FACPAC Contract Change Order Supplemental Information Form (Ref# 56328)

Tier 1 Project: ECHS Renovation Phase #7

Change Order - Construction Manager-Adviser Edition

CHANGE ORDER NUMBER: 12-2
INITIATION DATE: 5/3/2022

Estill County A T C project drawing UM1.0, Unknown Manhole #2 and Manhole #1.

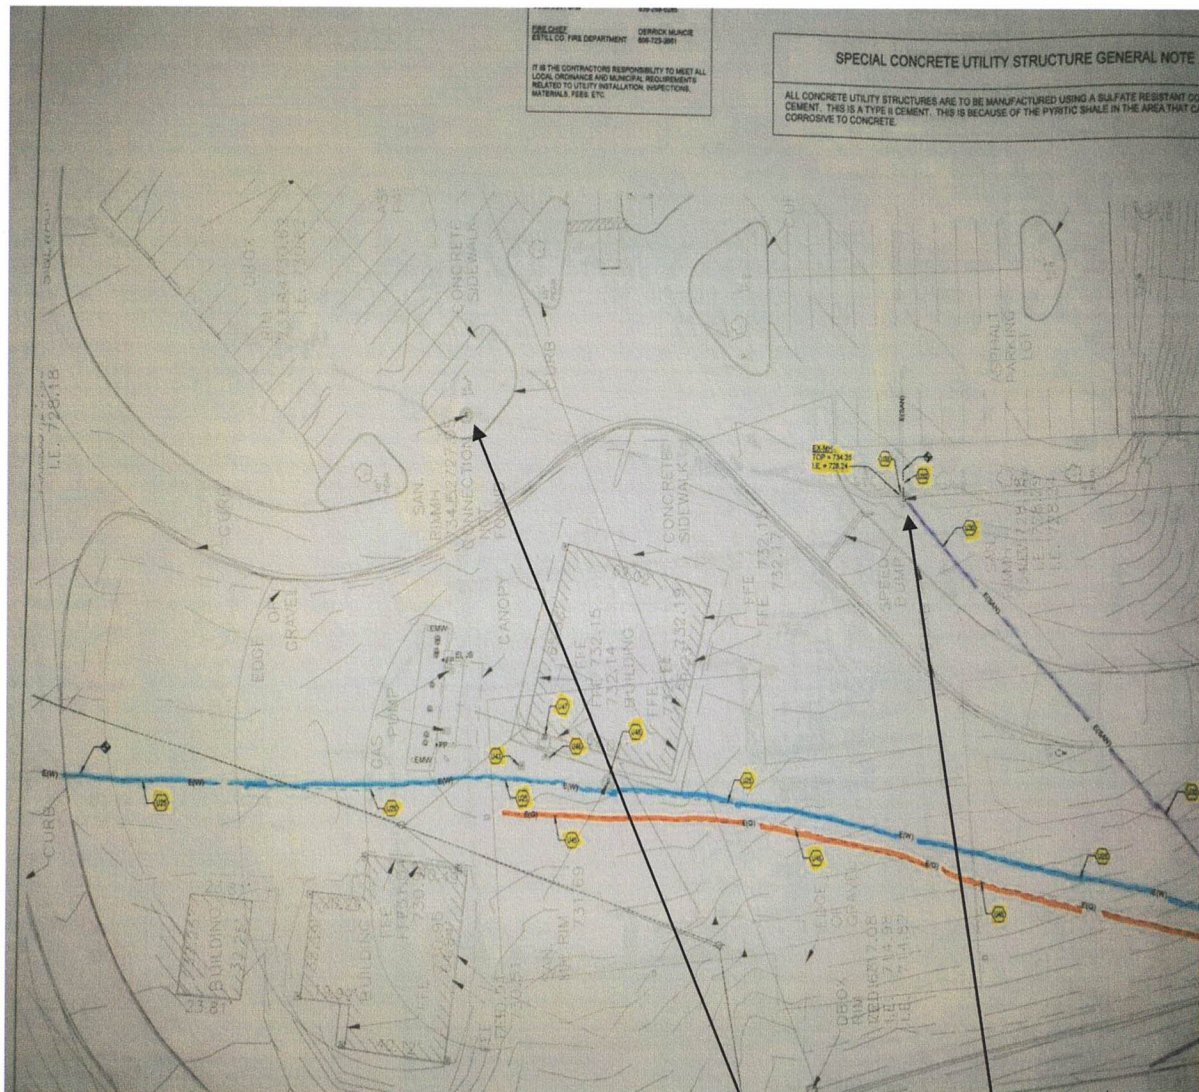
The Contractor shall clean and remove all blockage in the 4" sewer pipe leading towards the Baseball Softball Field drive way. The goal is to locate and confirm this pipe does terminate and end in the center of the driveway. Note; it is possible there is an unknown manhole located somewhere in this driveway or adjacent culvert. This unknown pipe if it does come from Manhole #2 shall be camera and the video recording submitted to the Architect, the laser distance take is +/- 285' from manhole #2 to the sign seen in the above picture.

The Contractor shall provide a unit pricing for extending the installed force sewer main from the present location north of Baseball Field fence to the 4" sewer in the entrance driveway.
